# ORIGINATION FORM

Proposed Revisions to a Standard Plans Index  
(Please provide all information – Incomplete forms will be returned)

Index Number: **120-001**  
Sheet Number (s): All Sheets  
Index Title: Embankment Utilization

Sheet 1: Added REMOVAL OF EXCESS BASE MATERIAL details from Index 000-506; Changed detail Notes.  
Sheet 2: Removed Treated Permeable Base reference (Patrick Overton).  
Sheet 3: New Sheet 2  
Sheet 4: New Sheet 3. Added Special Stabilized Subbase.

**FLEXIBLE PAVEMENT**

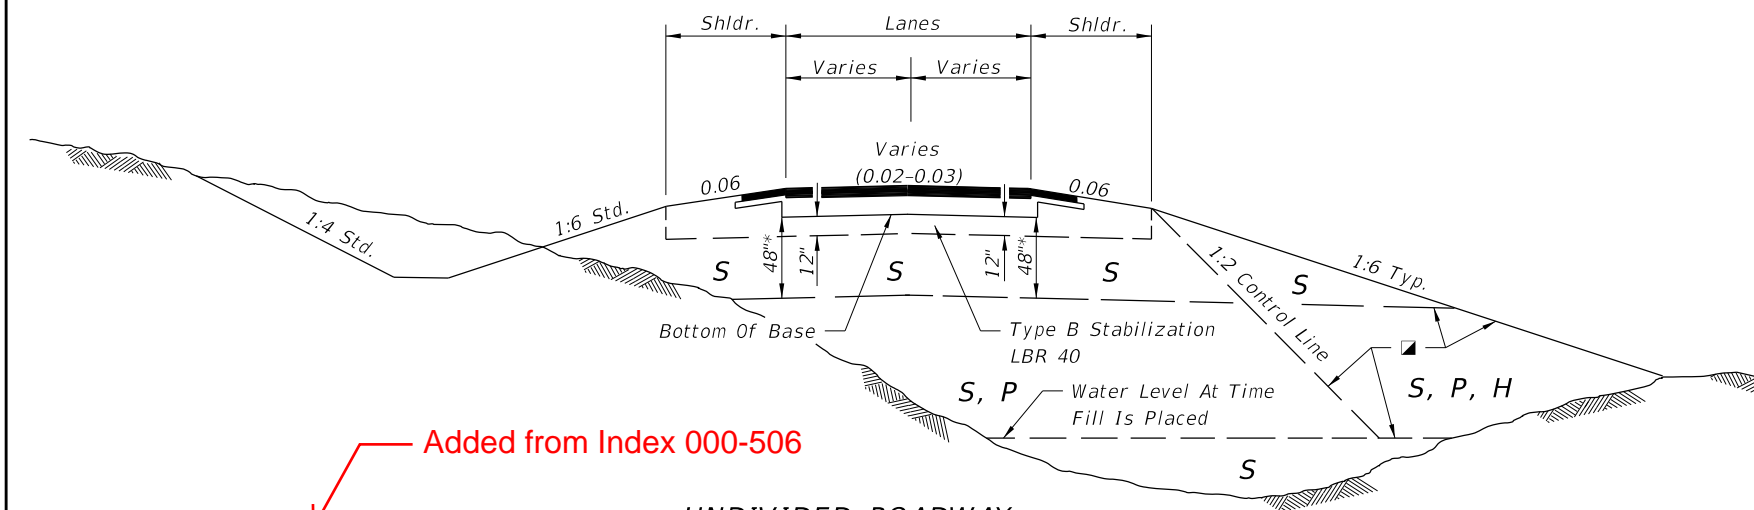
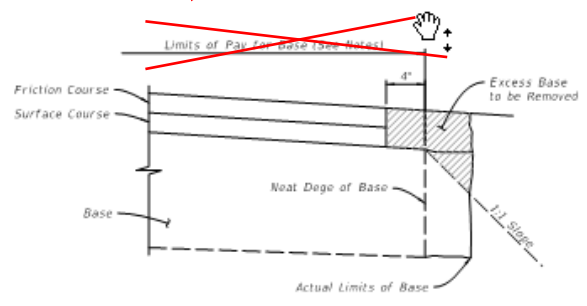
1. ~~The designer shall take into consideration the expectancy of roadway widening to the outside, and where widening is anticipated, specify in the plans the location of the future widening control line for utilization of High Plastic (H) soils and/or soils classified as organic material in the embankment.~~
2. ~~The designer shall take into consideration the position of the drainage swales in the portion of the embankment where Plastic (P) soils, High Plastic (H) soils, or soils classified as organic material would be allowed. The designer shall limit the use of Plastic (P) soils, High Plastic (H) soils, and/or soils classified as organic material to locations that will not inhibit the infiltration of stormwater from the swales.~~

DELETED

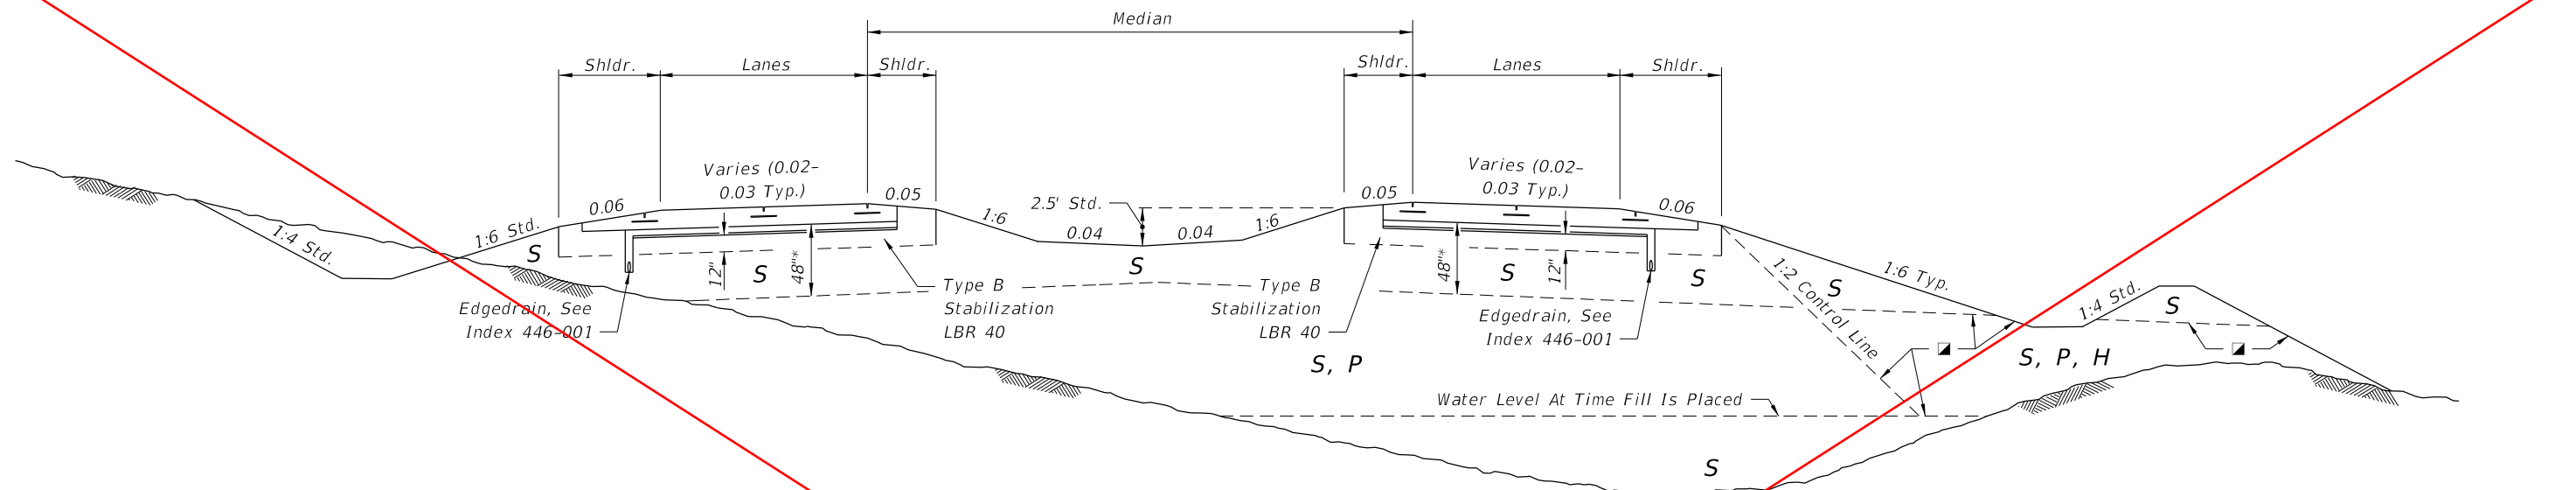
Added from Index 000-506

Changed Notes

**UPDATED NOTES**

1. The cost for removal of excess base material is included in the contract unit price for base.
2. Calculate payment for base using normal width.

**RIGID PAVEMENT - TREATED PERMEABLE BASE OPTION**

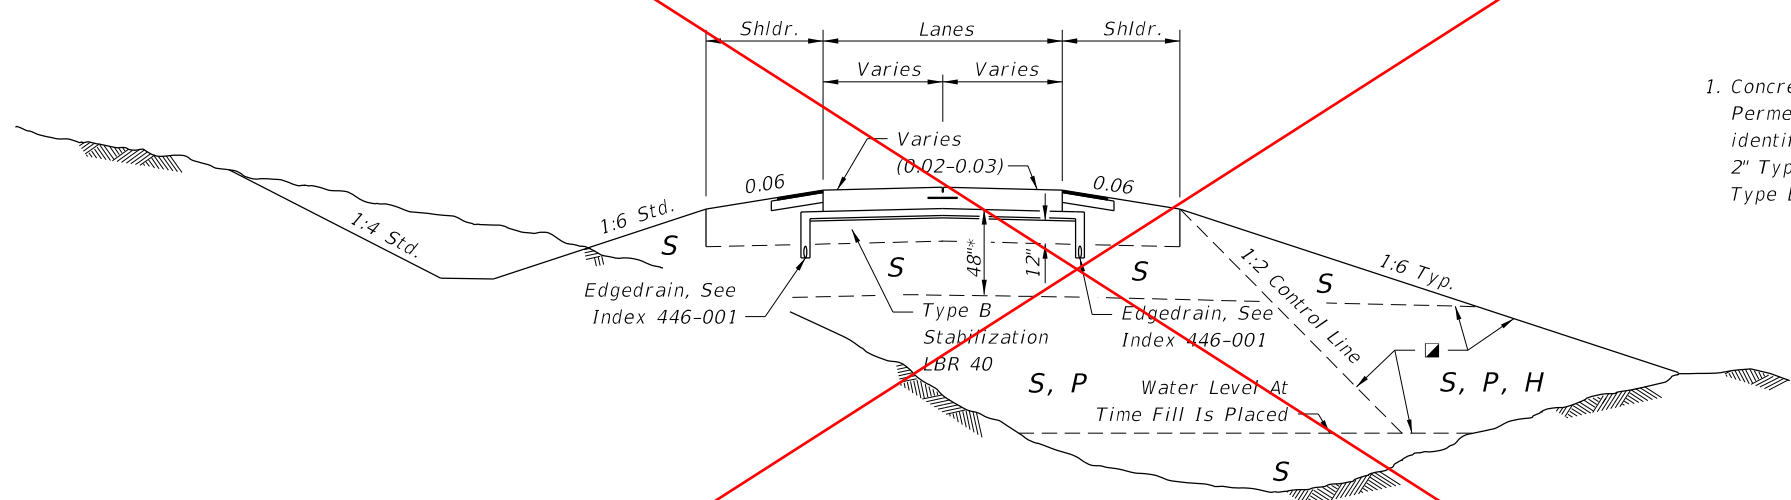
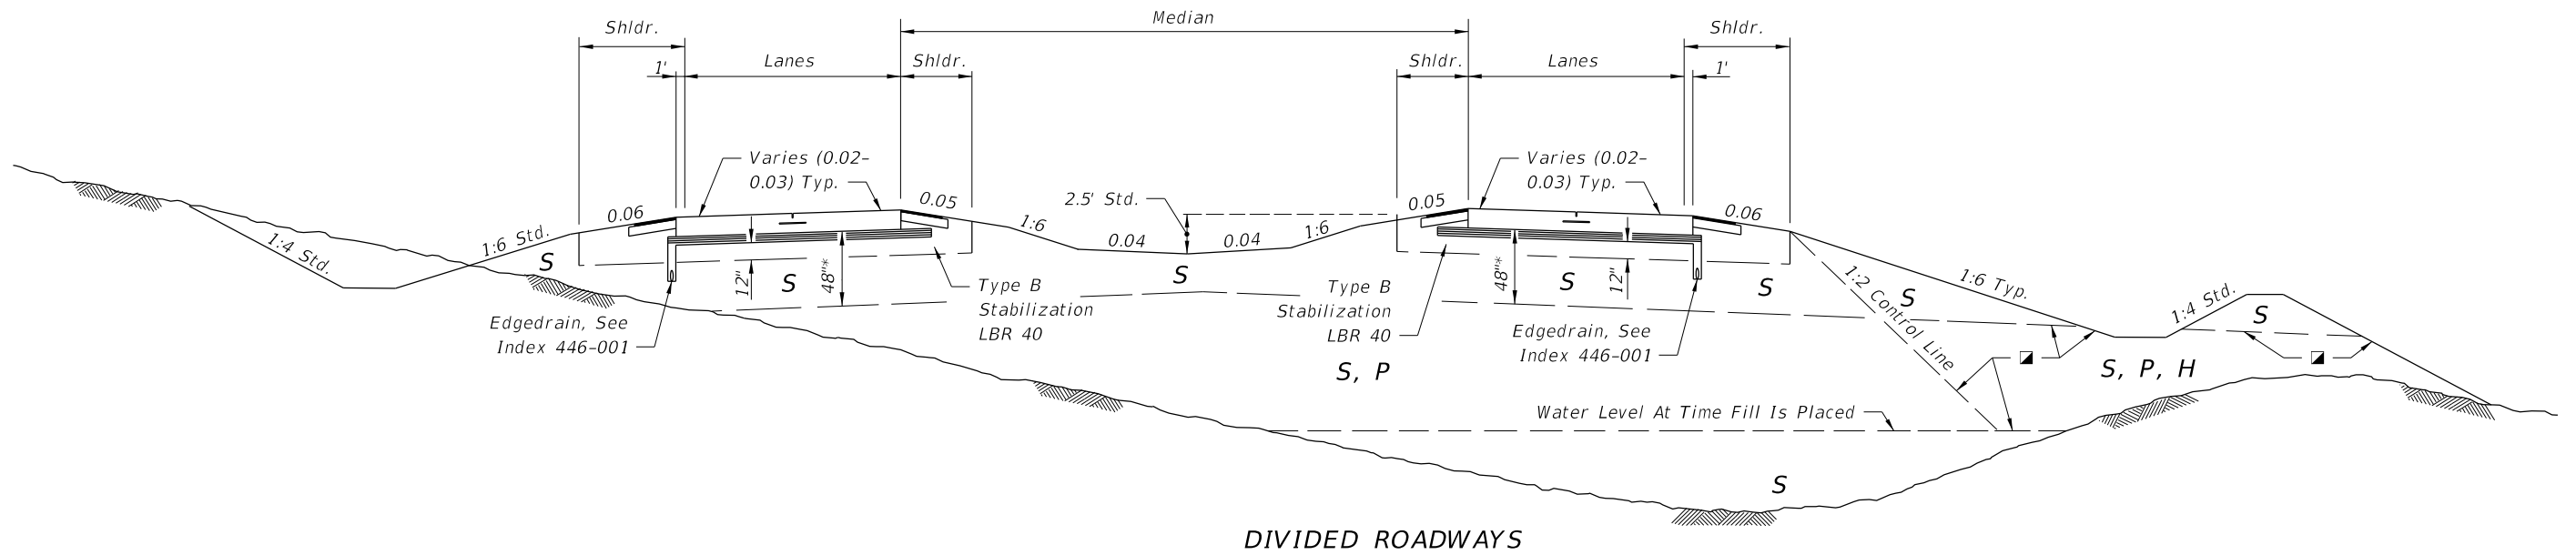
**DELETE SHEET -  
REMOVE TREATED  
PERMEABLE BASE OPTION**

RIGID PAVEMENT - ASPHALT BASE OPTION

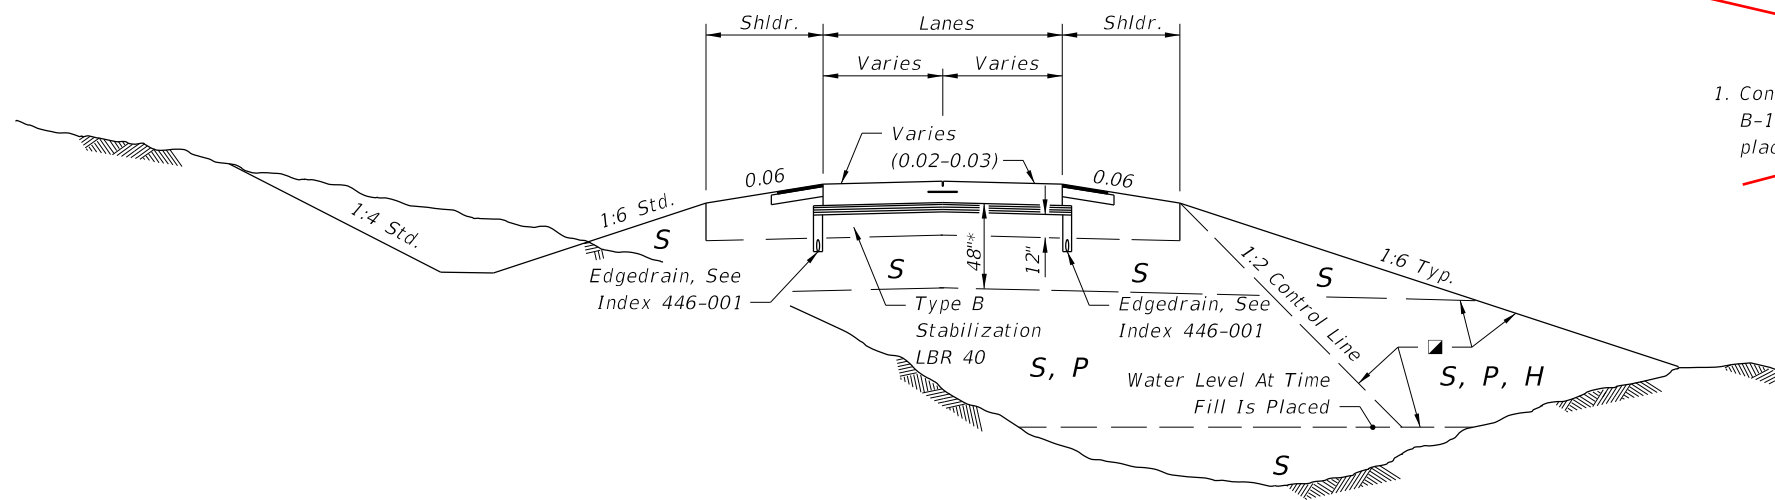
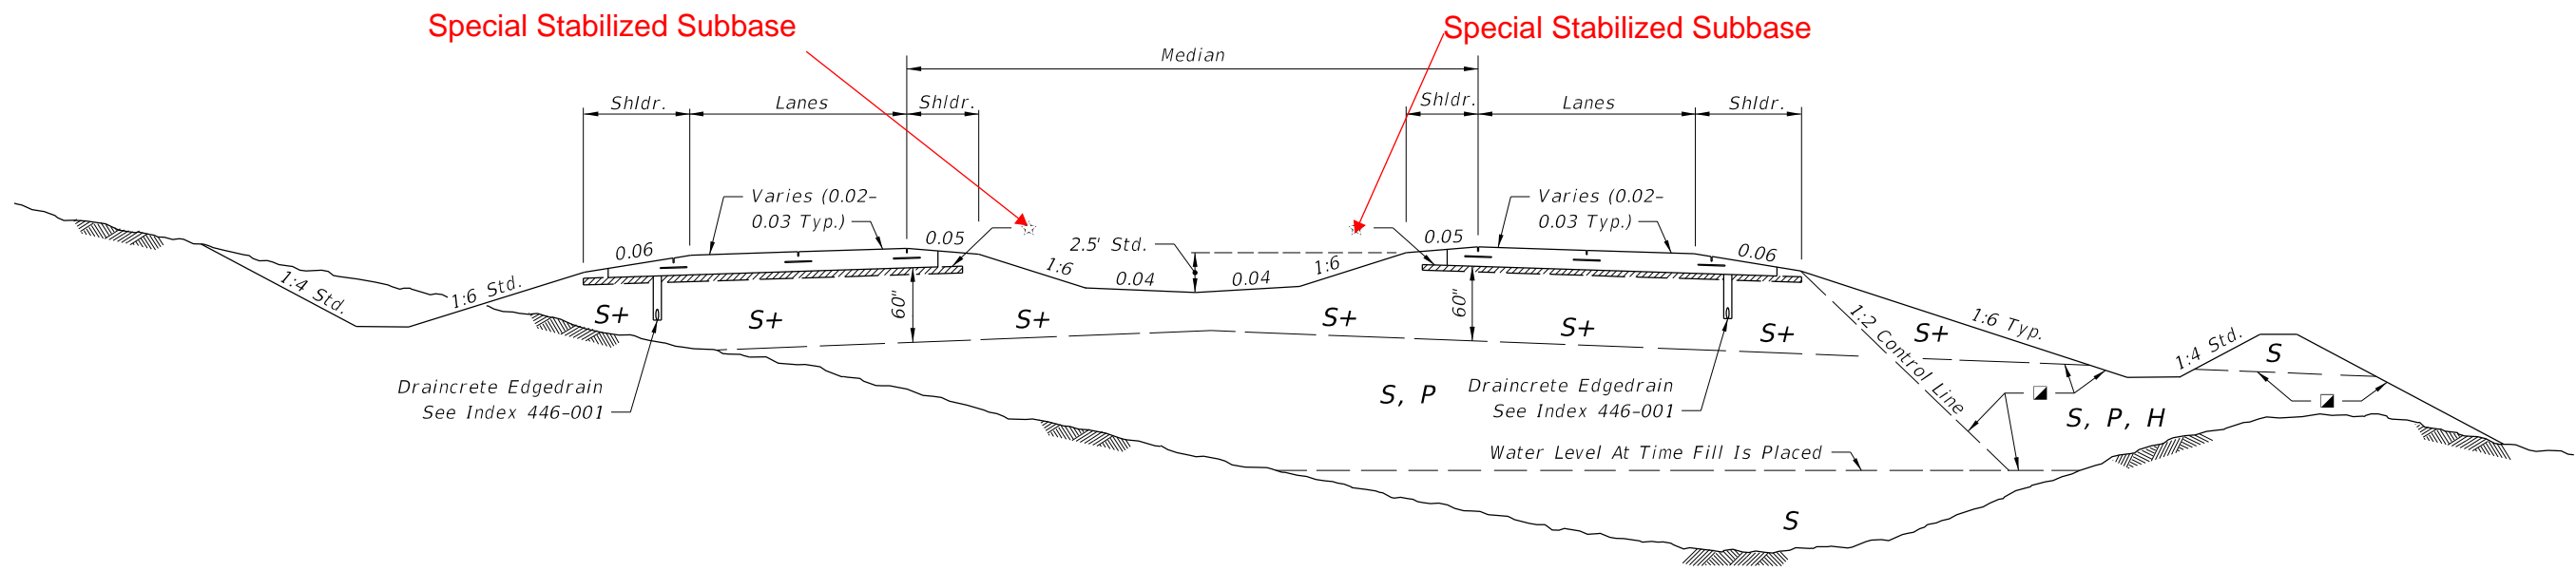
~~DESIGN NOTE~~  
 1. Concrete pavement is to be placed over Optional Base Group 1 Type B-12.5 only Asphalt Base as identified in the plans. This will be placed on a working platform using 12" of Type B Stabilization.  
 DELETED

RIGID PAVEMENT - SPECIAL SELECT SOIL OPTION

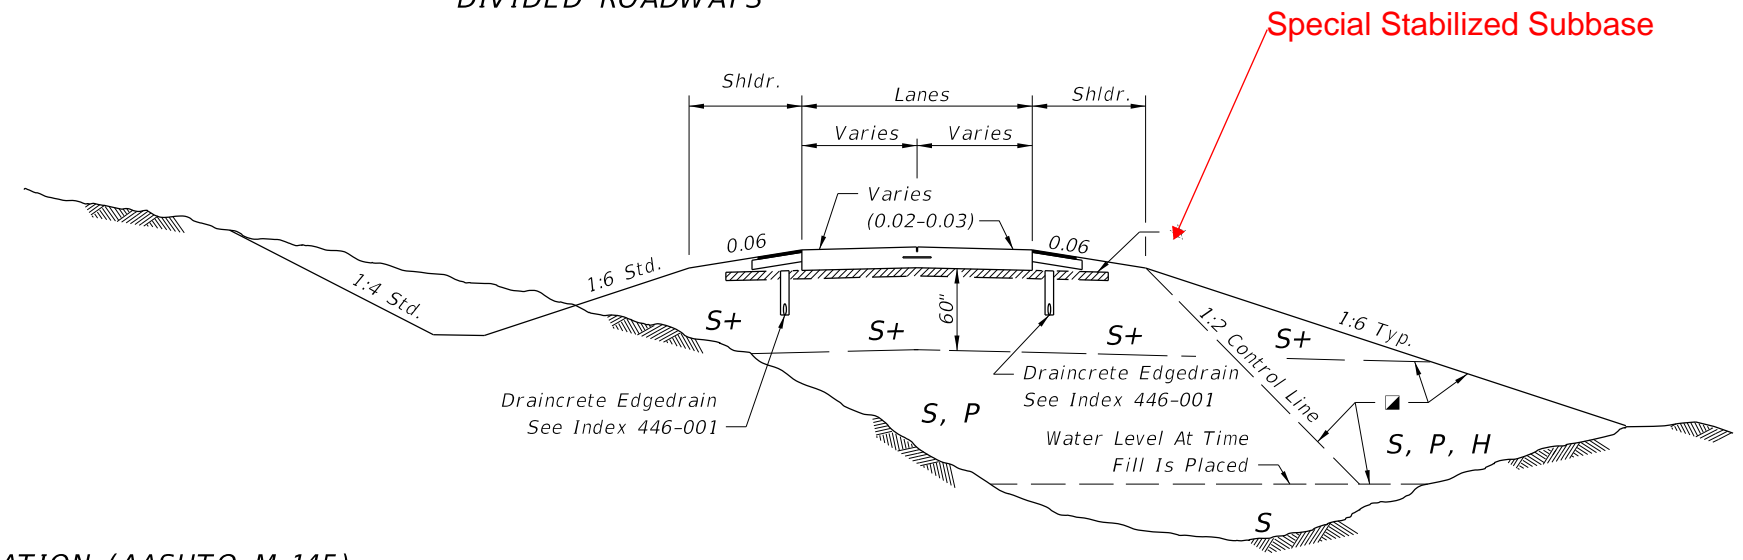
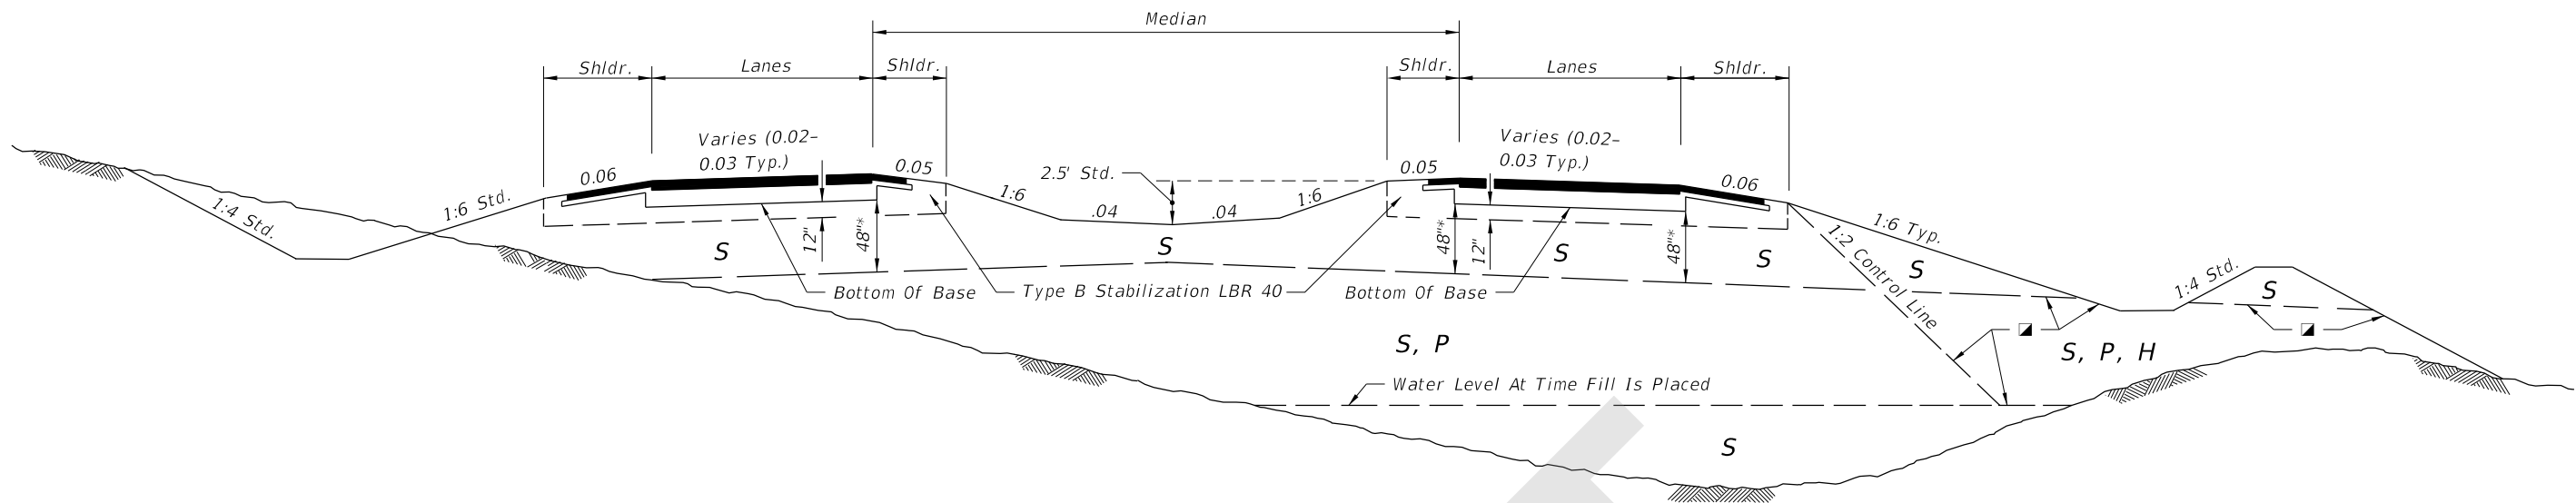
**DELETED**

~~Note: SPECIAL SELECT SOIL OPTION may be used only when approved in writing by the District Materials Engineer and shown in the plans.~~

3" of #57 or #89 Coarse Aggregate Mixed Into Top 6".

**Special Stabilized Subbase:**
